MITCHELL PARK HORTICULTURAL CONSERVATORY DOMES Peer Review

Final Report

March 14, 2017

WJE No. 2016.2700

Figure 9. Section through hub from original drawings showing hub cladding drainage system

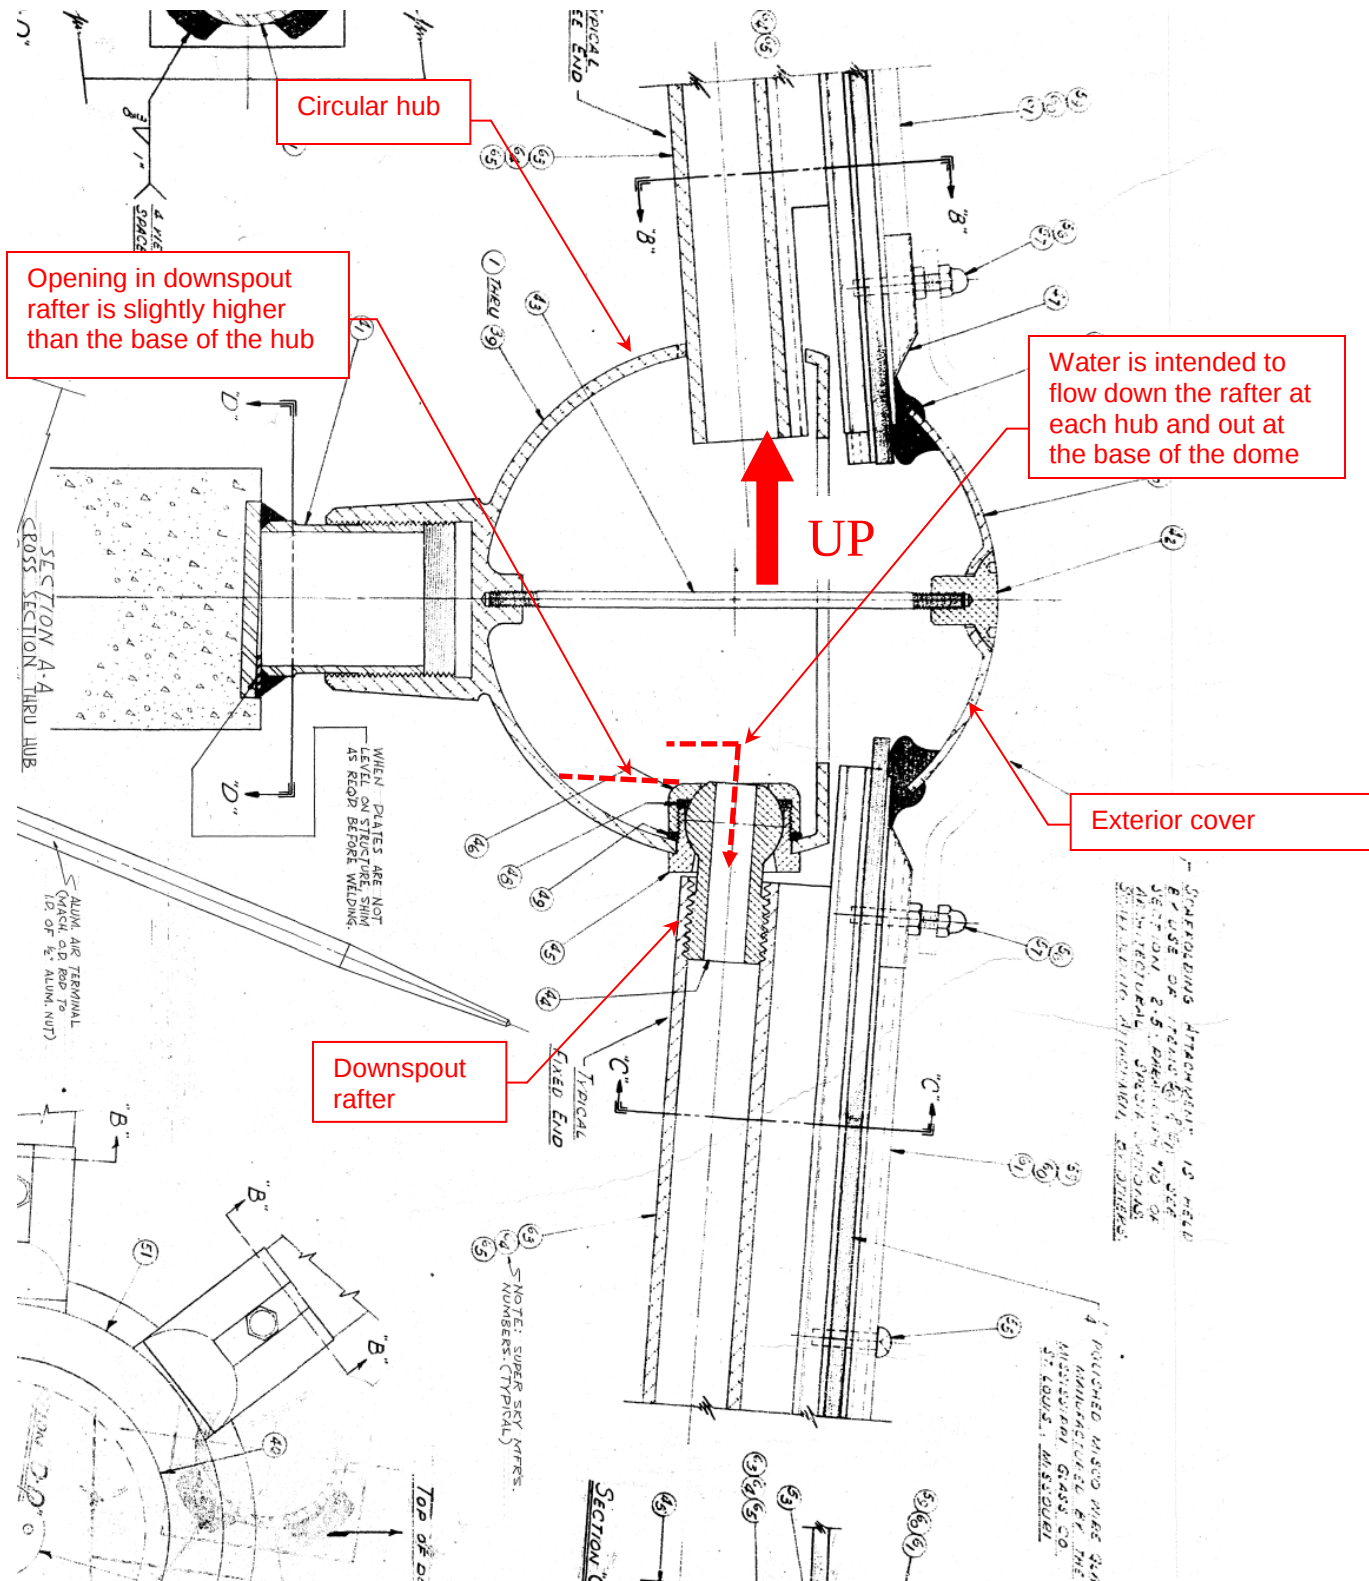
- GRAEF reported that water leakage throughout the domes has historically been a problem and still remains an ongoing issue. GRAEF reported that water was observed sitting in the hub and not allowed to drain. They attribute this problem as due to the fact that the downspout rafter extends higher than the base of the hub (see Figure 9).

Figure 25. Section through glass and aluminum frame showing conceptual pressure cap repair for consideration

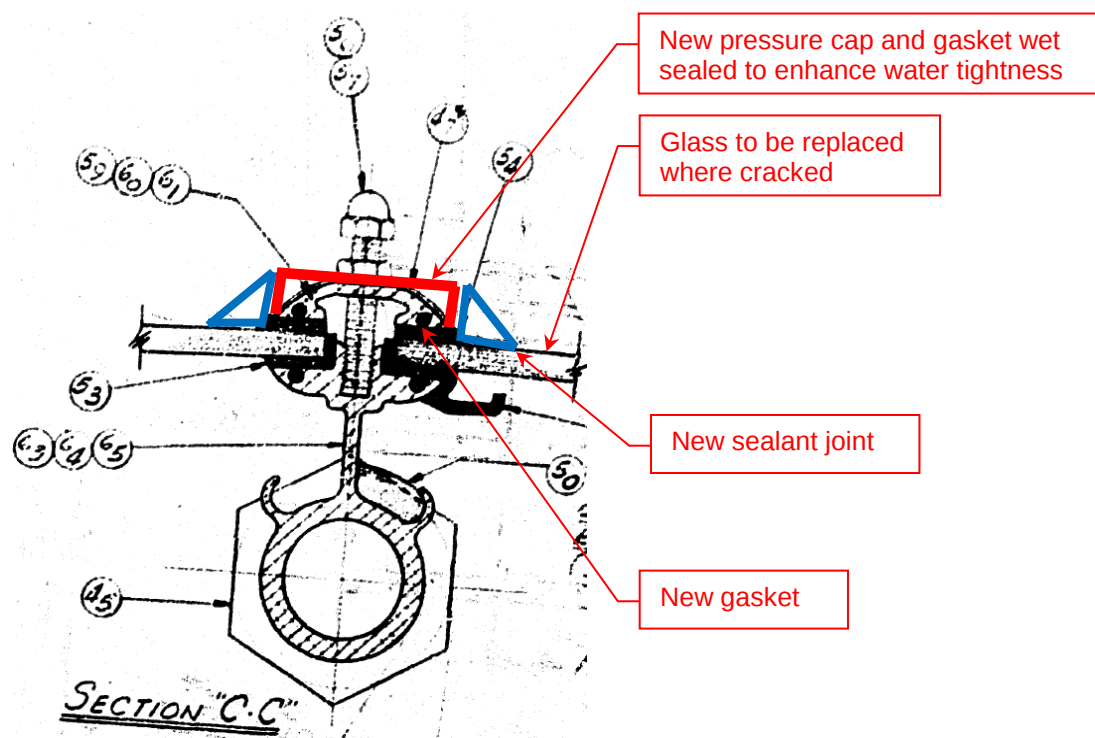
- For weather protection, WJE would normally recommend resealing the glass to aluminum joints around the dome. This is usually performed by a "wet seal" between the glass and the exterior aluminum (the pressure cap). In this case, however, the edges of the existing pressure caps are thin. Obtaining an adequate wet seal joint between the pressure cap and glass would be difficult. As an alternative, removing and replacing the pressure cap with a new redesigned pressure cap would allow for additional weather protection by: a) replacing the exterior glazing seals between the glass and the pressure cap with new glazing seals, and b) a thicker edge detail on the new pressure cap, which would allow a wet seal to supplement the new glazing seal. We believe that this redesign would largely resolve rain water leakage through the dome. We believe that this is a practical step for GRAEF to consider as an addition to their Option 1 repair.

1. Replace existing cracked and broken wired glass in kind, or with laminated glass. Modifications in the glass replacement design could be implemented based on the findings from further investigation and mock-up repairs.
2. Remove and replace all pressure caps and wet seal joints (Figure 25).
3. Clean hubs and install self-leveling sealant at leading hubs (Figure 26).
